File FP-1996-160

Name: Wilson Ranch Townhomes – Final Plan – I-70 / 25 ¾ Rd.

**Wilson Ranch Townhomes
Response to Staff Review Comments
FP-96-160**

LANDSCAPE PLAN
 WILSON RANCH TOWNHOMES

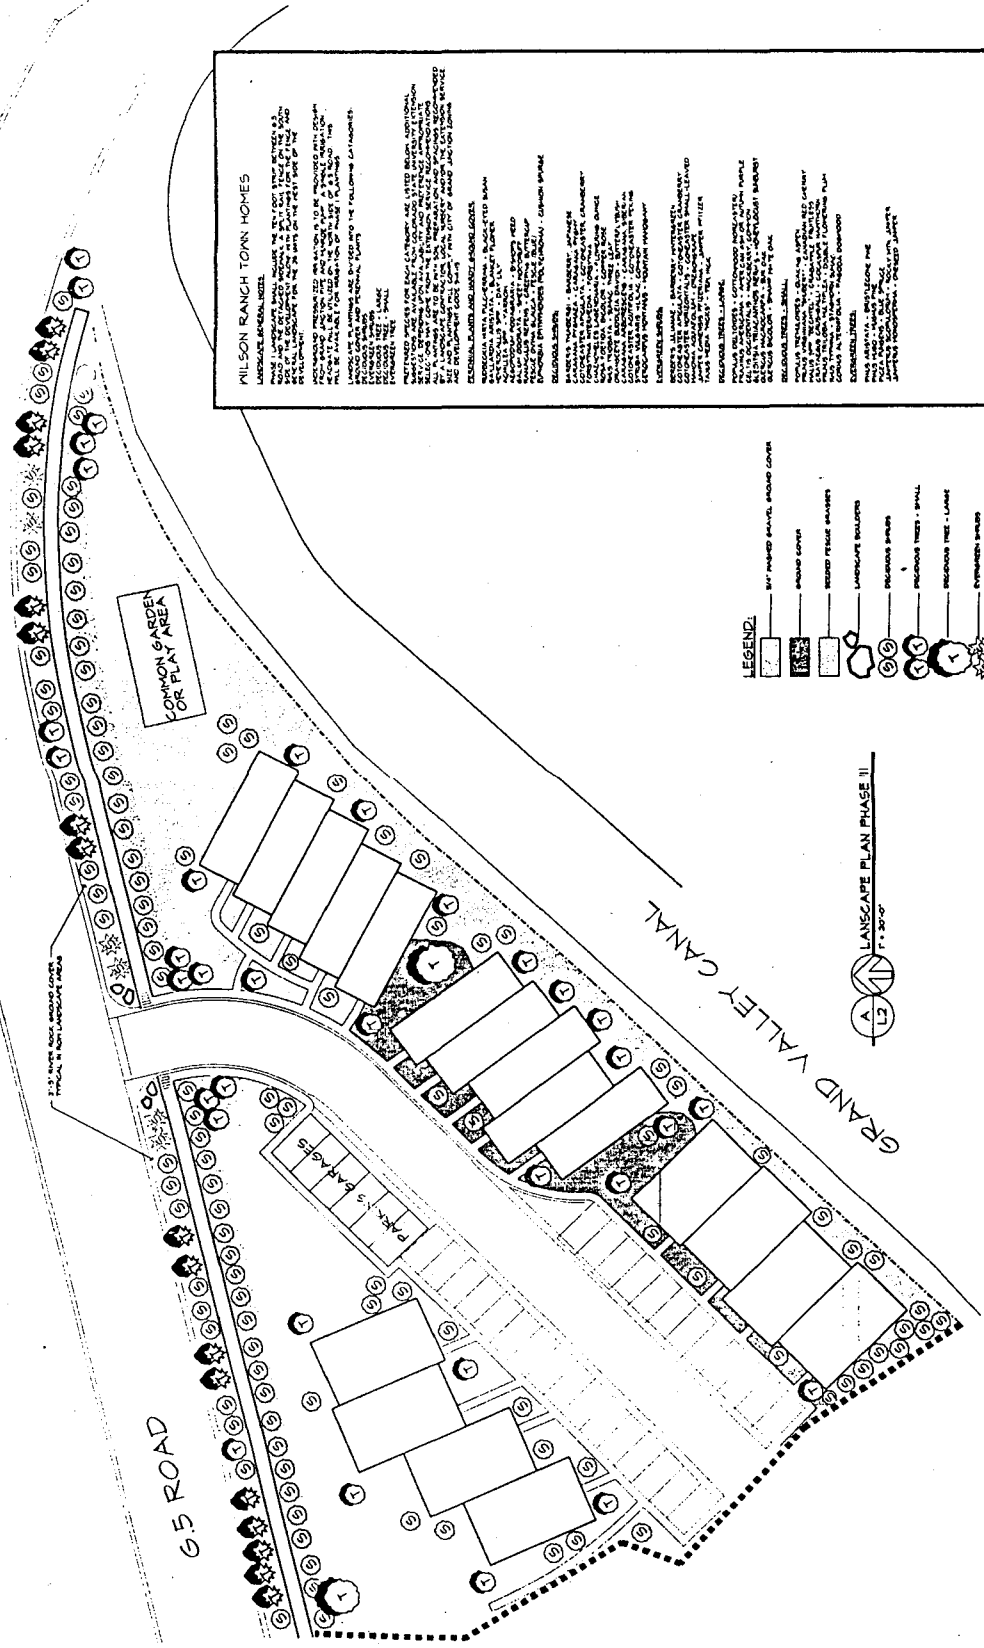
- 8. Plan states that, "size and plantings will comply with City of Grand Junction Zoning and Development Code 5-4-15." Does that mean that even the small trees will be at least 1.5 inches in caliper and shrubs will be at least 5 gallon size?

9. Generally the landscape plan appears to be acceptable. The final plan shall be subject to review and approval before installation.

4. **LANDSCAPE PLANS:**
Ensure that no shrubs encroach within 10' of the sewer MH-4.

COMPOSITE PLAN
WILSON RANCH TOWNHOMES
 Grand Junction, Mesa County, Colorado

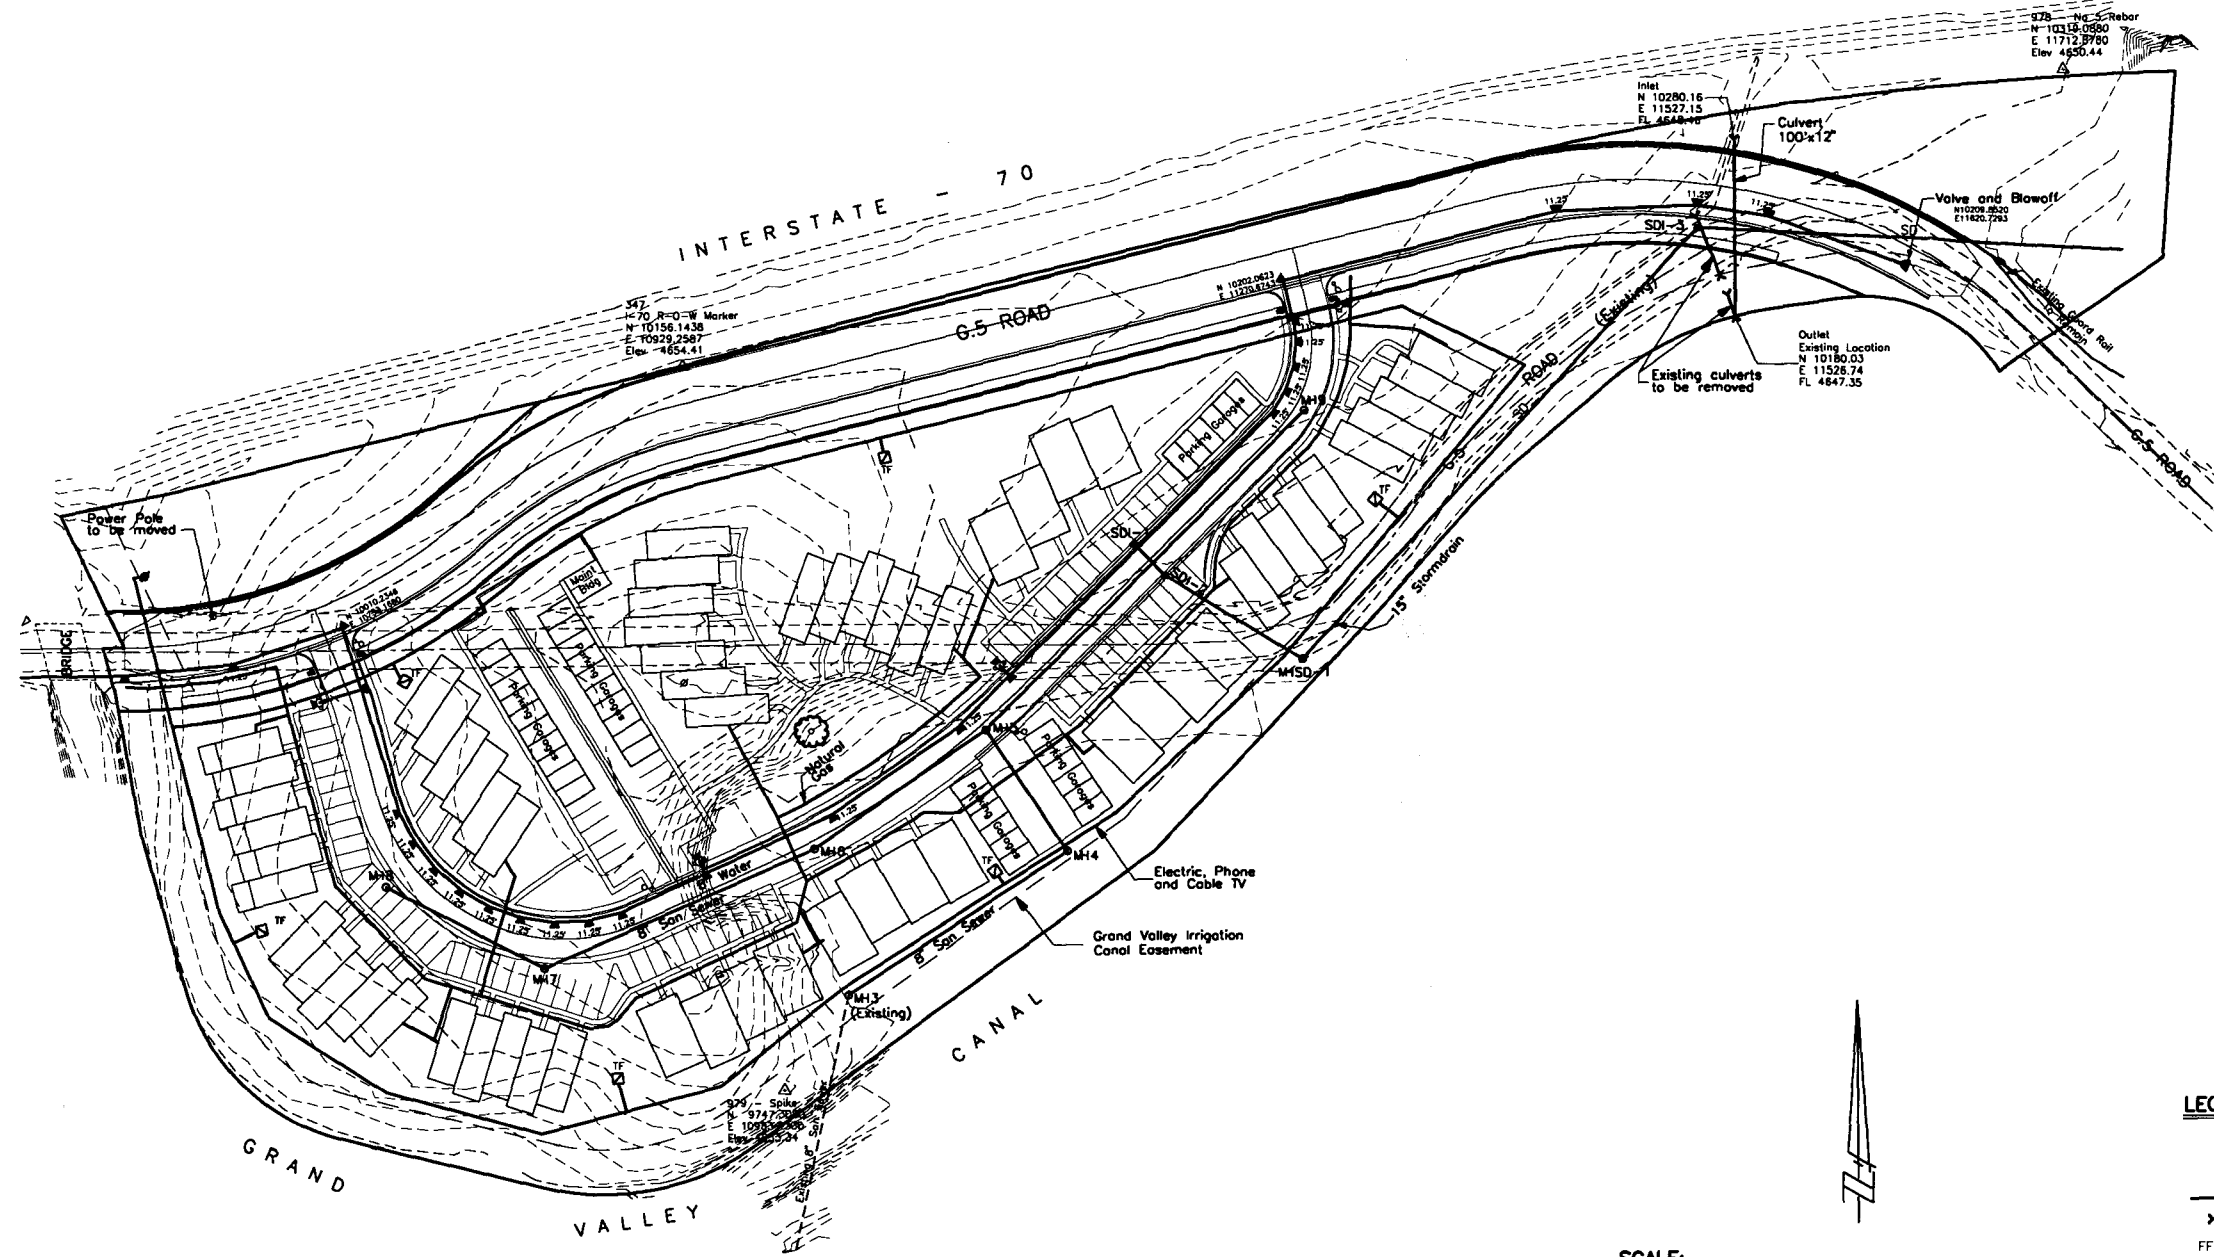
- 7. Site Plan does not meet SSID specifications. Without more detail this plan cannot be approved. Comments and conditions on other plans may change after submittal of a site plan with sufficient detail to review.

Site plan has been revised to meet SSID specifications.
